United Church

Planning Consultation Response - Design Amendment

June 2026

3.1 Accessible Parking Provision

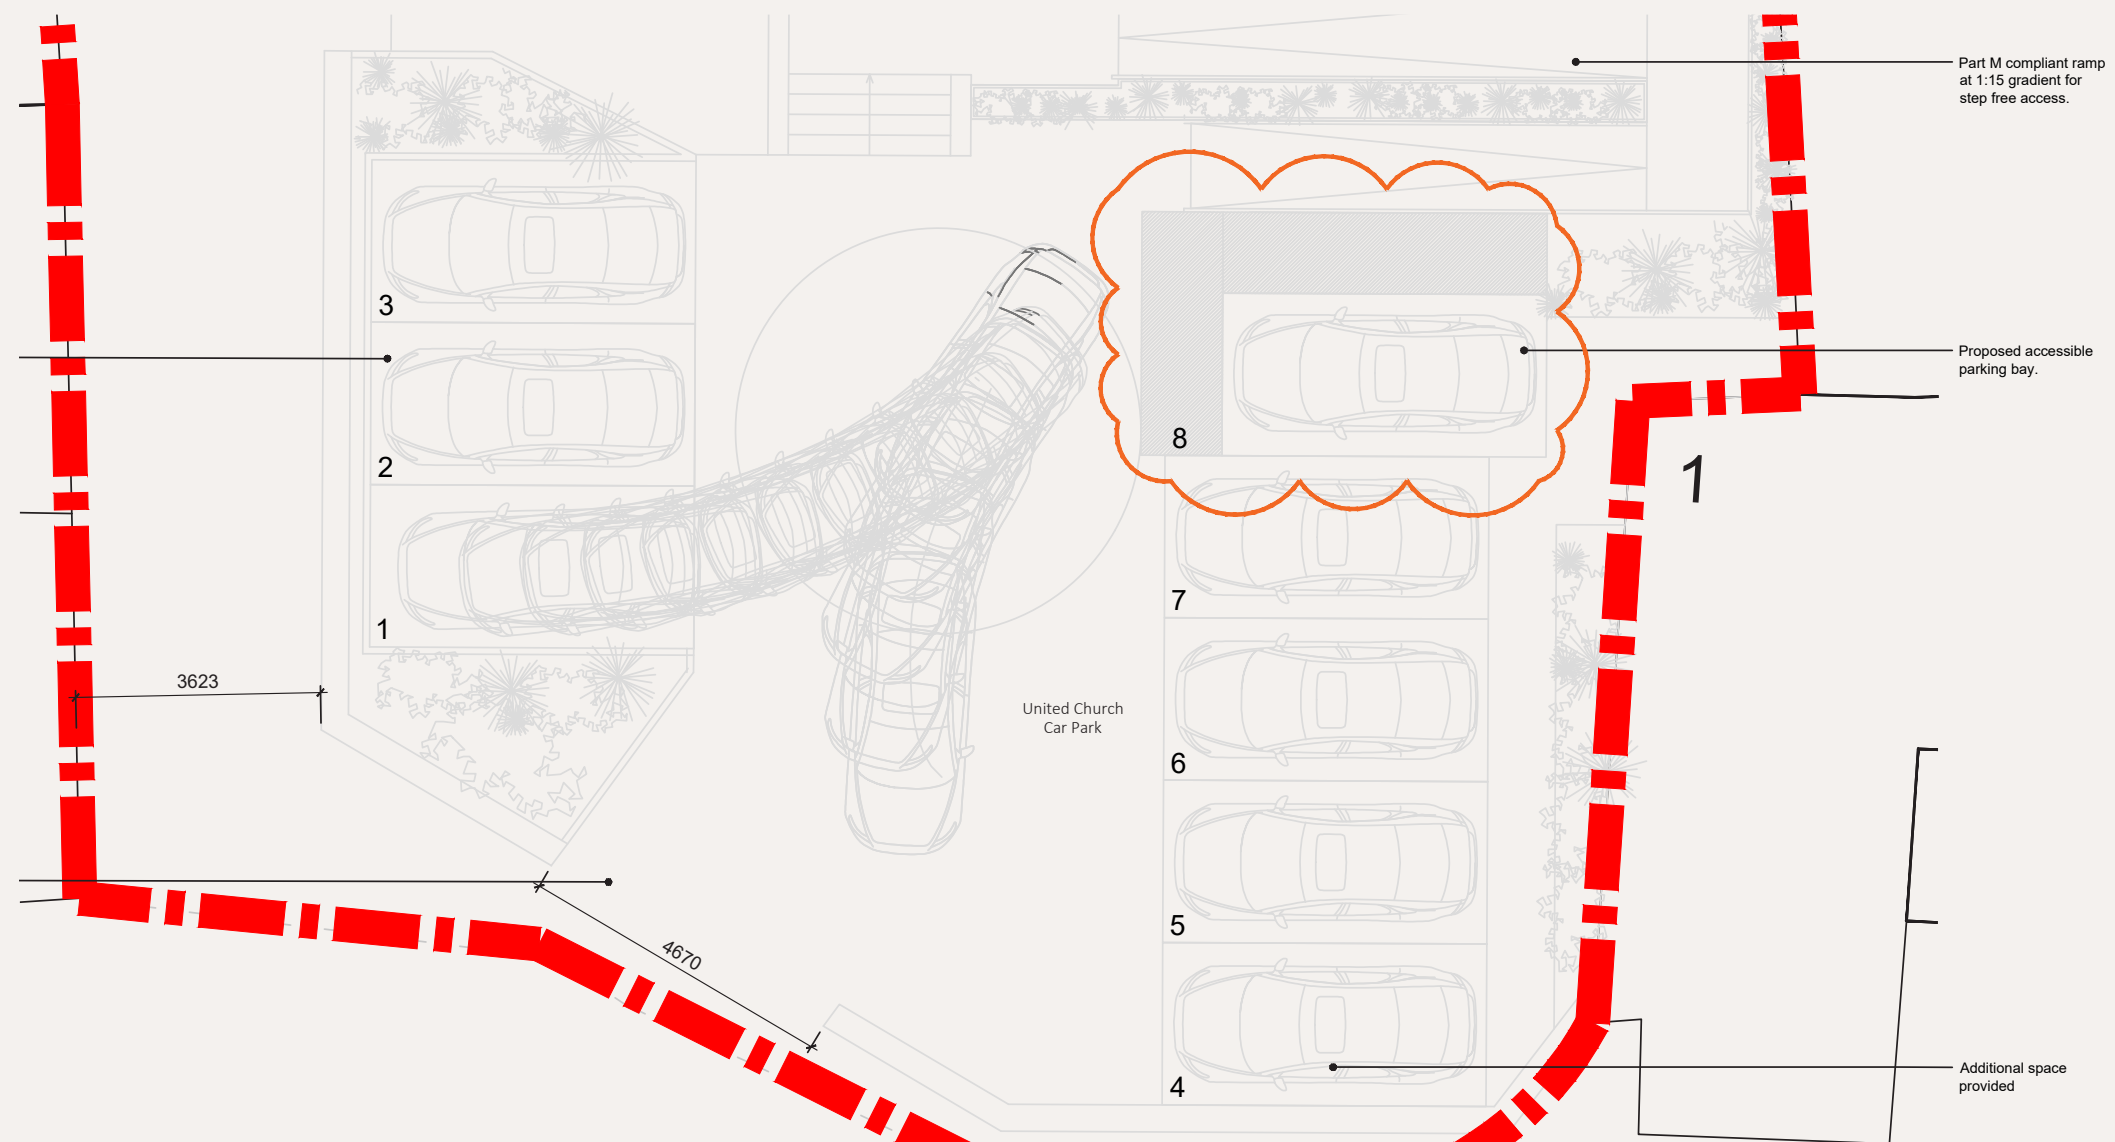
The proposed accessible parking bay has been reviewed and amended in response to comments received from the Local Highway Authority.

The parking space has been enlarged to provide the required 1.2m side access aisle and 1.2m rear access aisle, improving accessibility and ensuring the parking arrangement better accommodates wheelchair users and those with reduced mobility.

Minor amendments have been made to the adjacent landscaping to accommodate the revised bay layout. These changes have no material impact on the overall appearance or functionality of the development.

3.4 Cycle Storage Provision

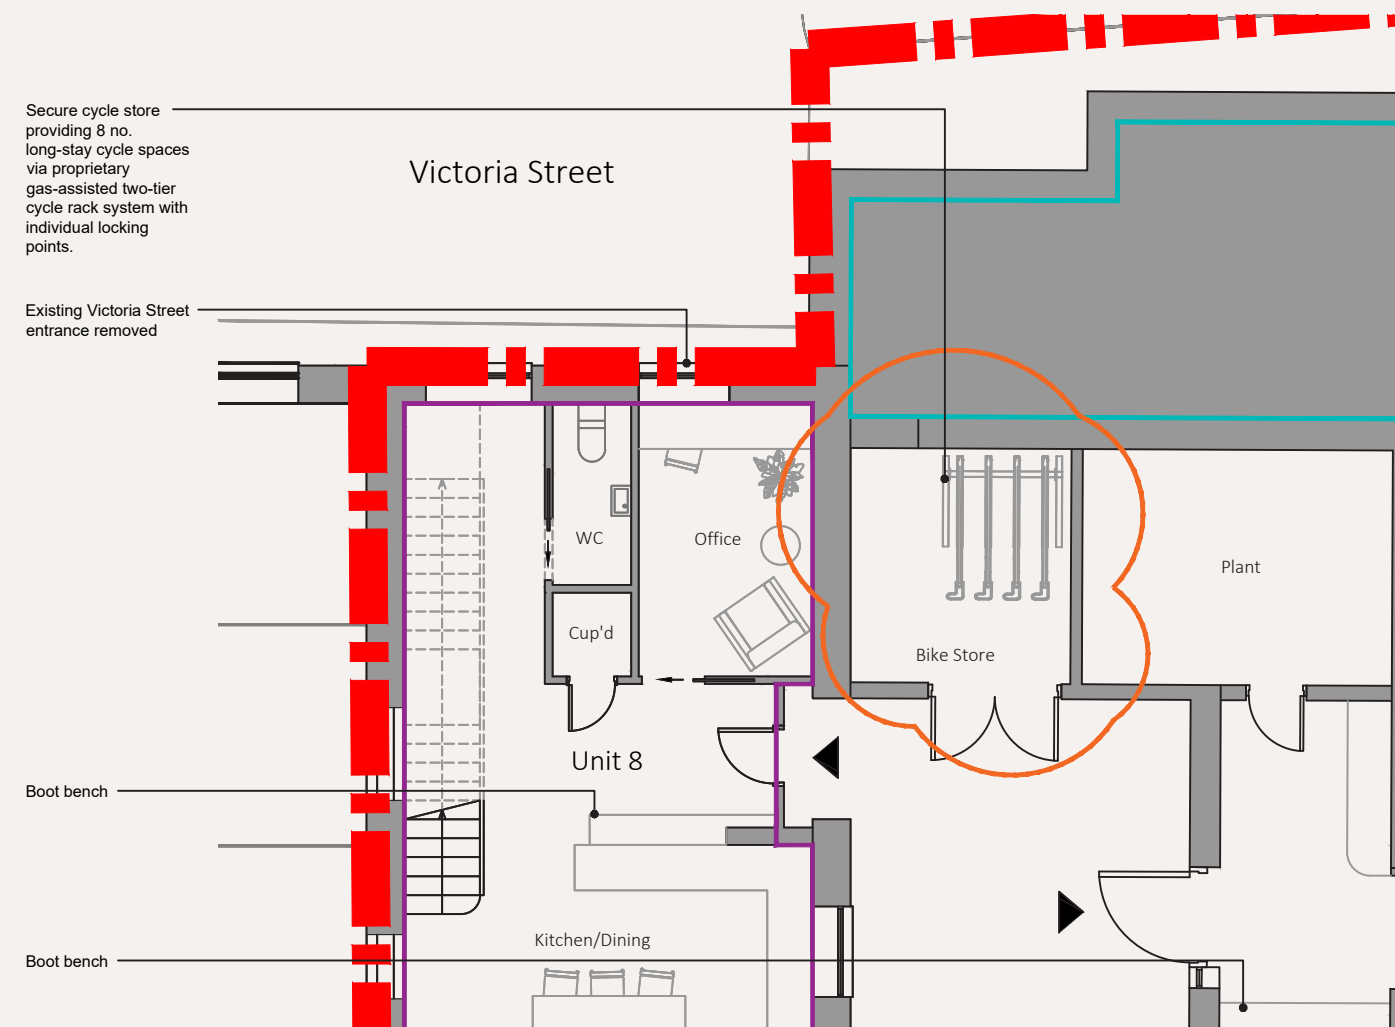
The original cycle store has been reviewed and updated to provide secure long-stay cycle storage for 8 bicycles, in accordance with the requirements of the Local Highway Authority.

The revised proposal incorporates a proprietary gas-assisted two-tier cycle rack system with individual locking points, an example shown below.

The arrangement provides secure, independently accessible cycle parking whilst making efficient use of the available floor area within the existing building.

The revised facility increases provision from 6 to 8 cycle spaces and addresses the requirements of the consultation response

3.5 Refuse & Recycling Provision

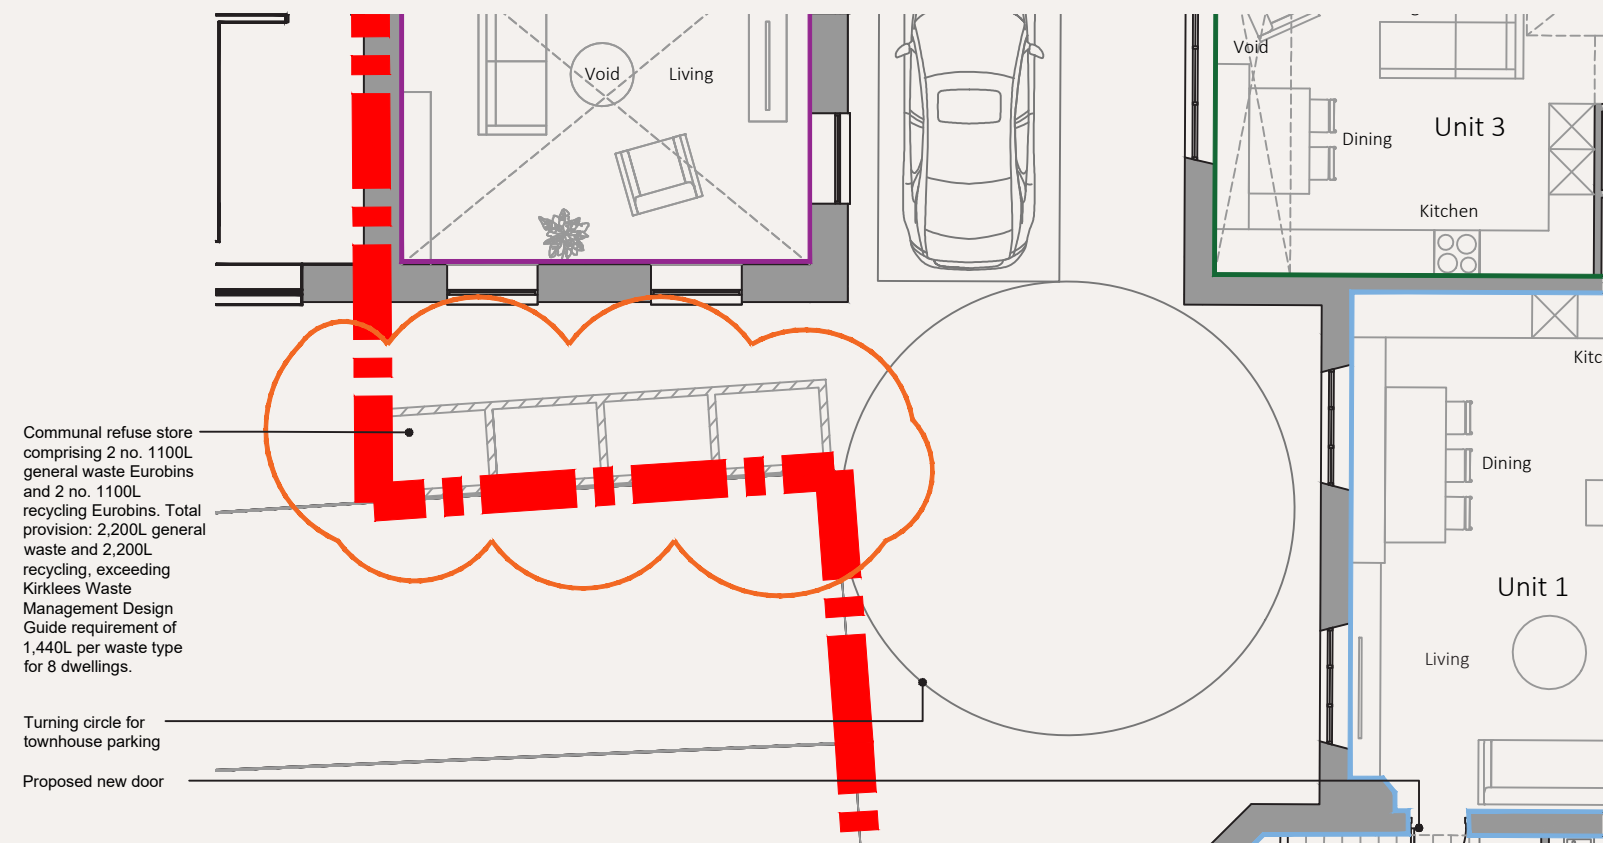
The refuse storage arrangements have been reviewed against the Kirklees Waste Management Design Guide.

2 no. 1100L General Waste Eurobins
2 no. 1100L Recycling Eurobins

2,200L general waste capacity
2,200L recycling capacity

Kirklees guidance requires 180L of storage capacity per dwelling per waste stream. For 8 dwellings this equates to a requirement of 1,440L for general waste and 1,440L for recycling.

The proposed arrangement therefore exceeds the required storage capacity whilst remaining appropriate for the constraints of the site and the conversion of an existing heritage building.

title:
Proposed Second Floor Plan

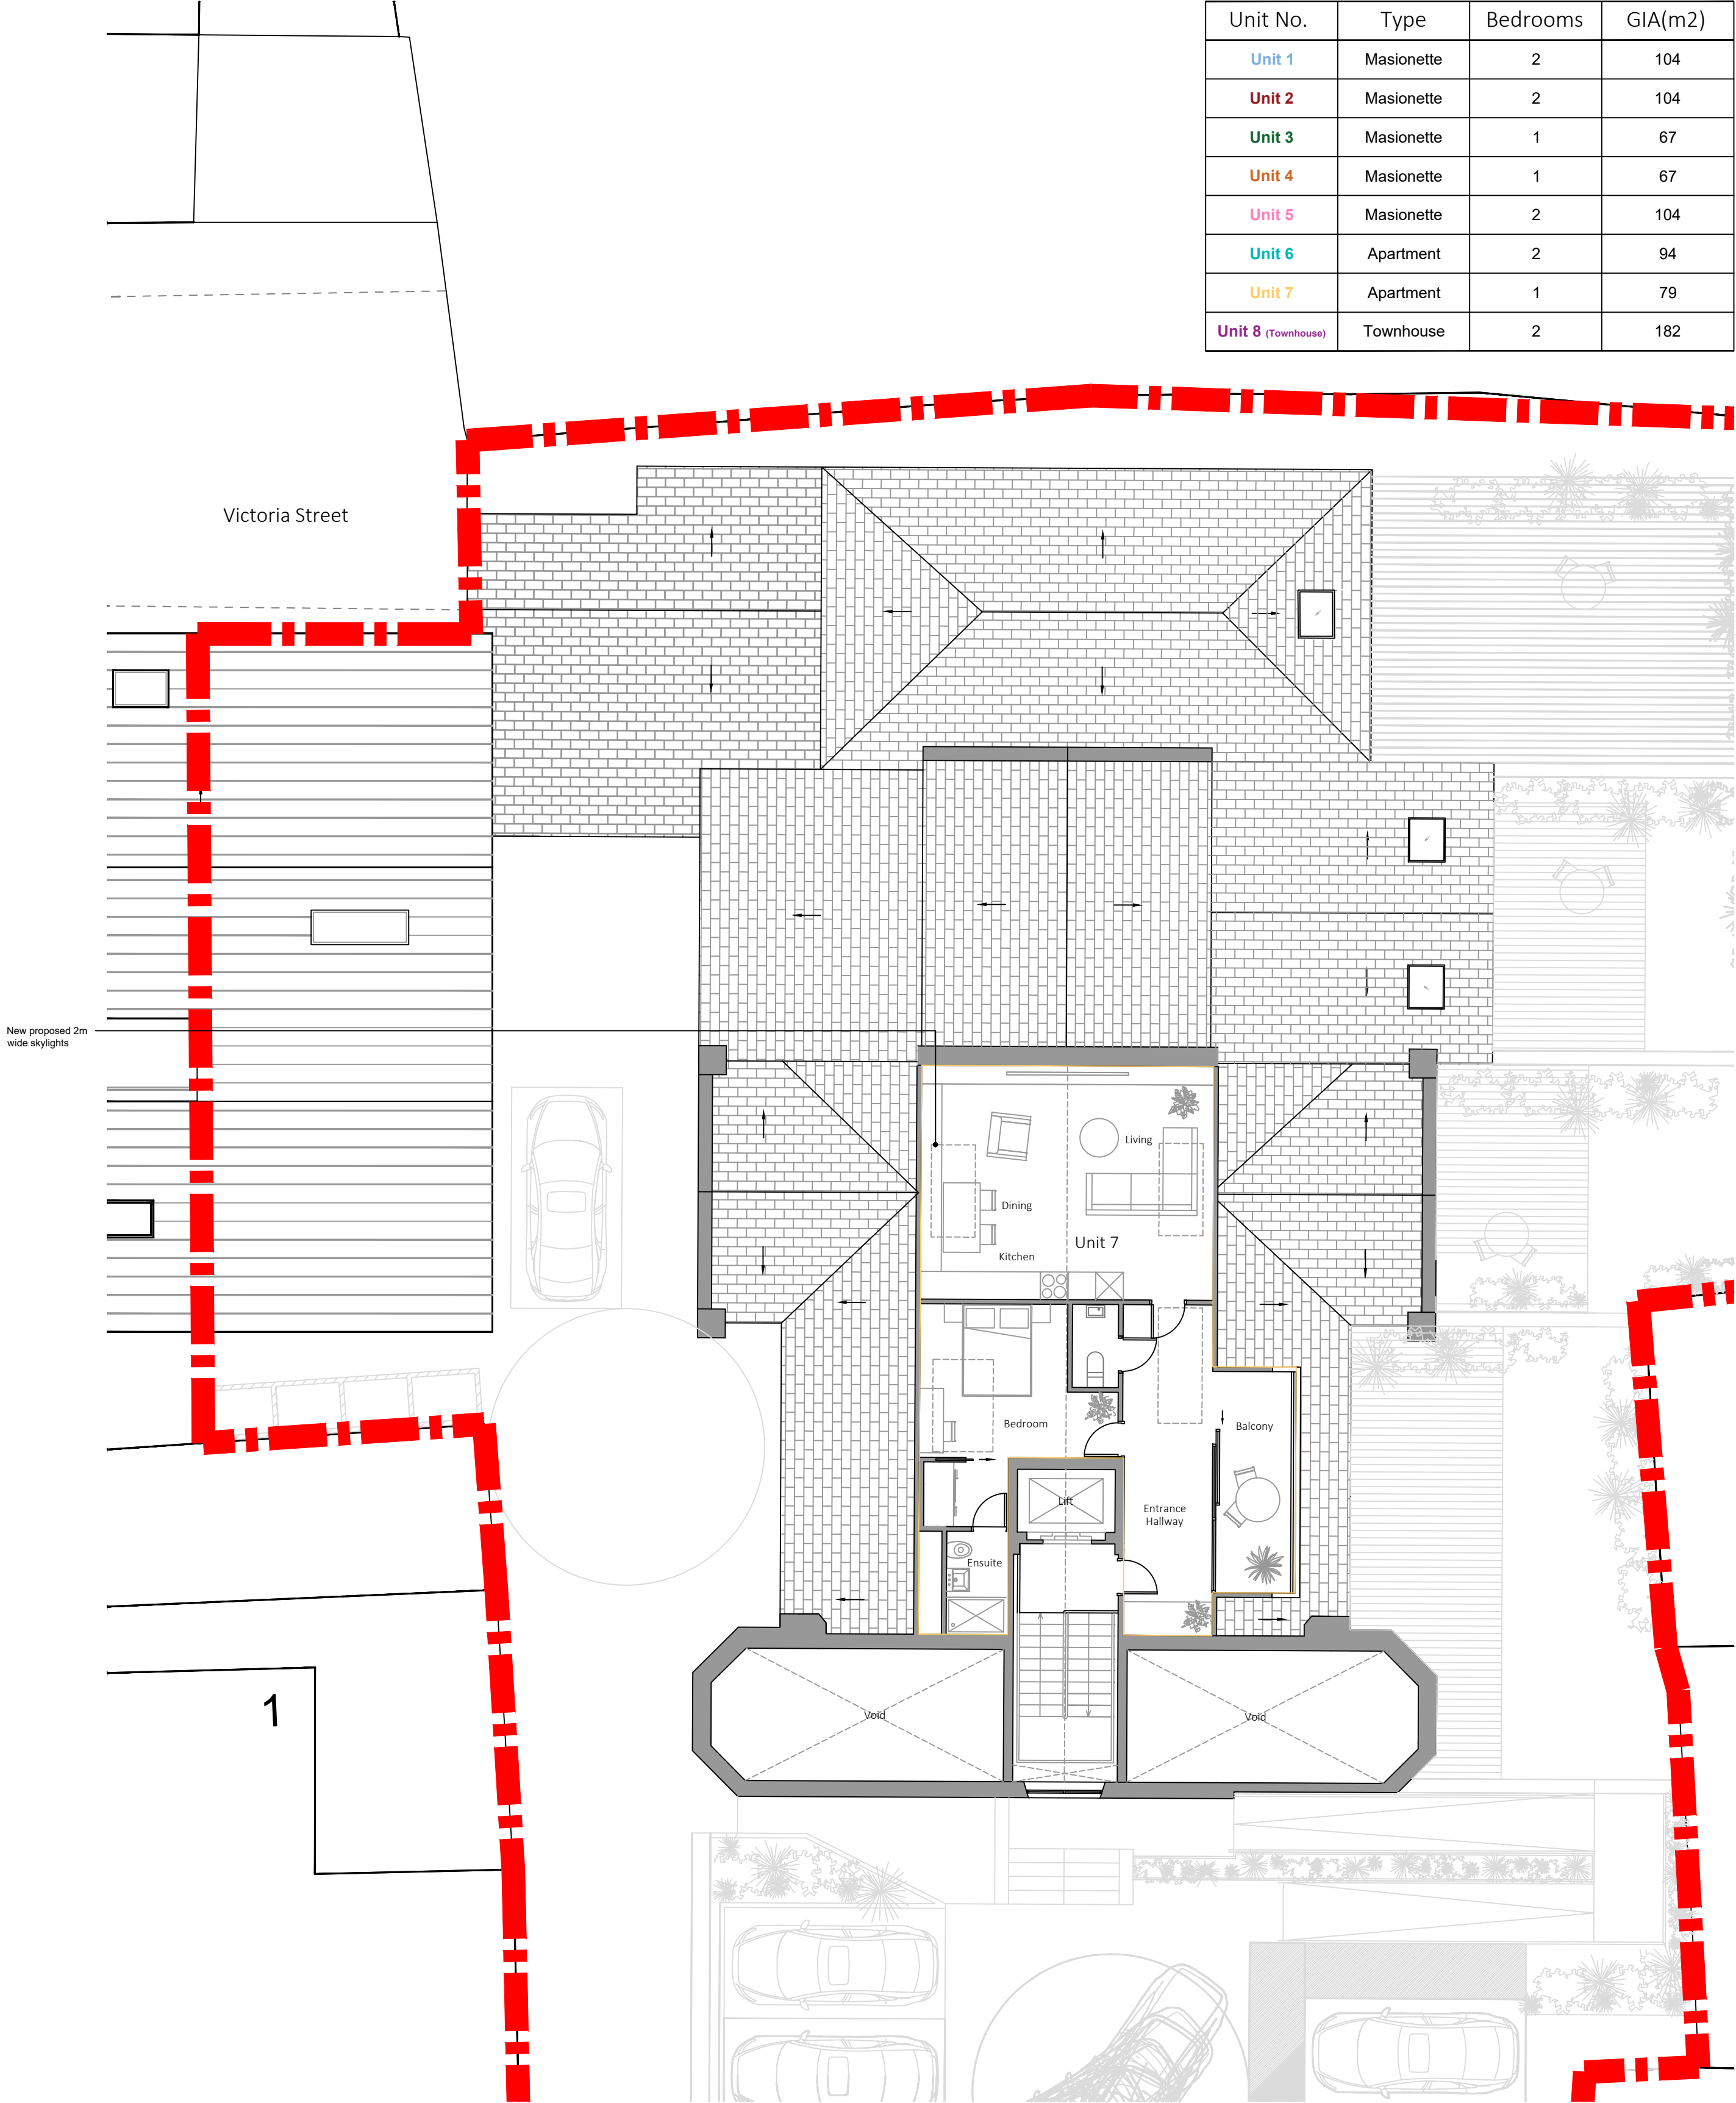
The Conservation Officer expressed concerns regarding the scale and prominence of the proposed rooflights.

The second floor layout has been amended accordingly to accommodate the revised rooflight arrangement.

title:
Proposed Site & Roof Plan

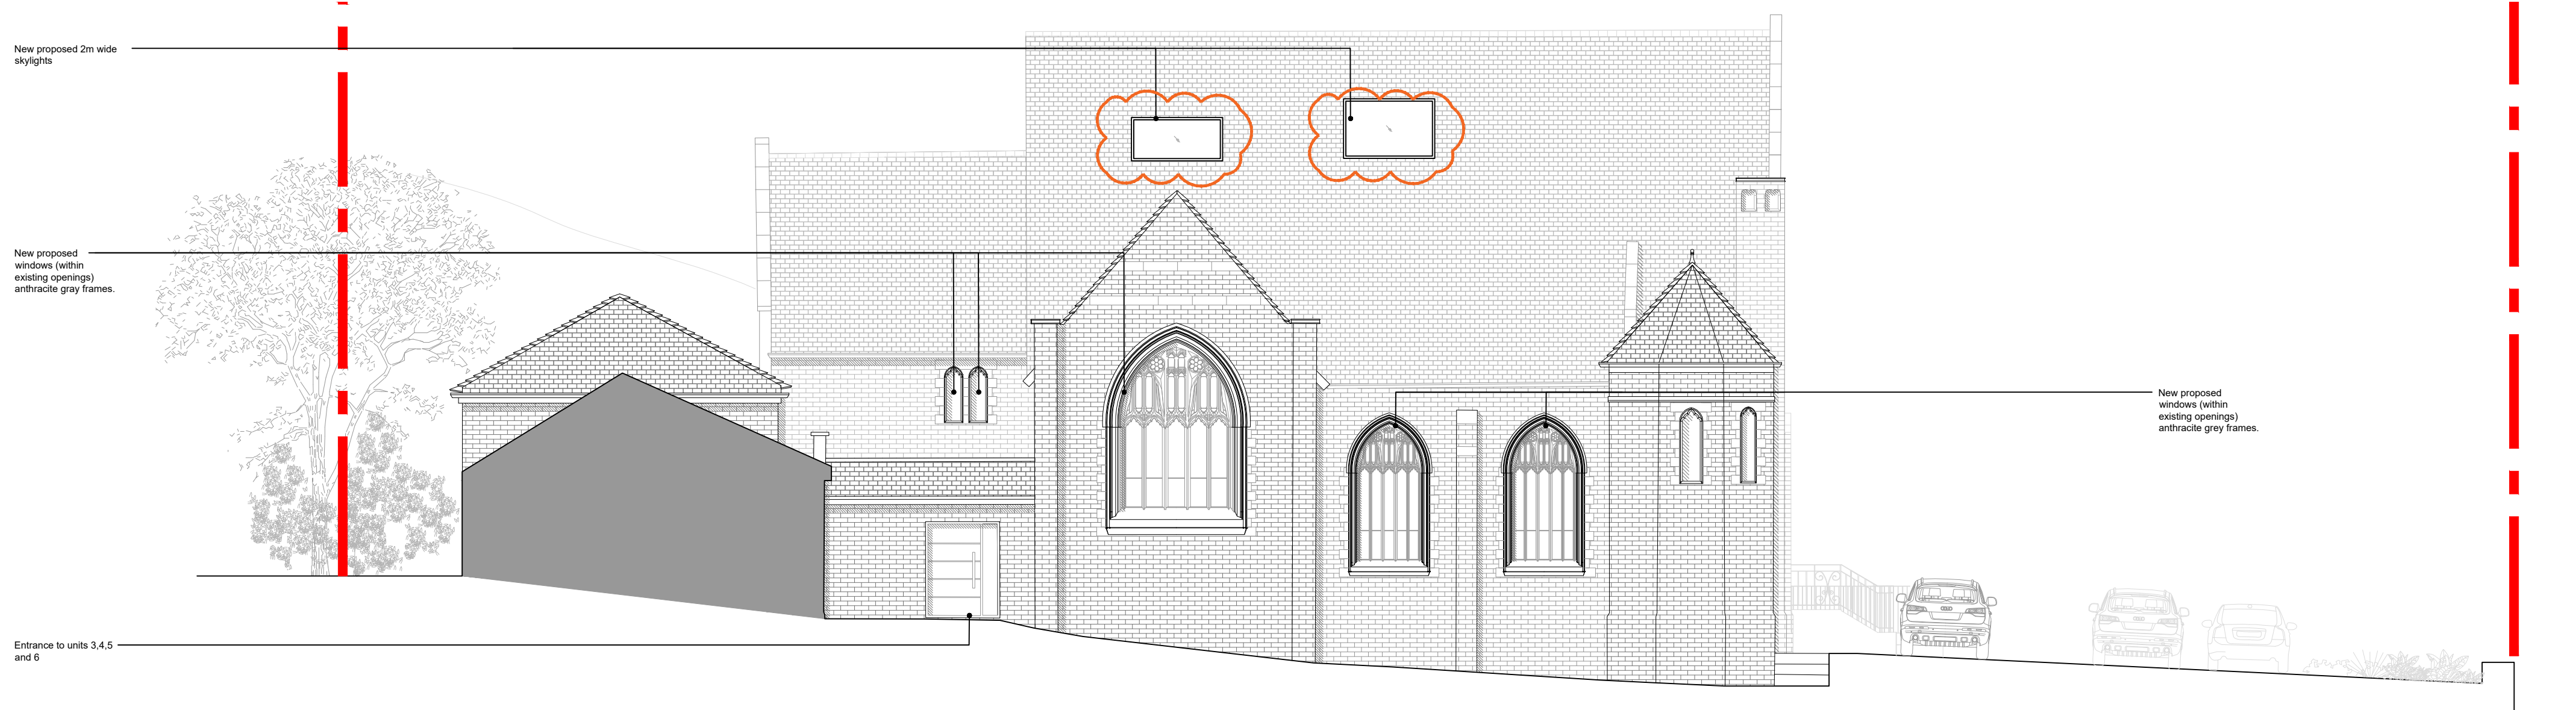
Proposed accessible
parking bay.
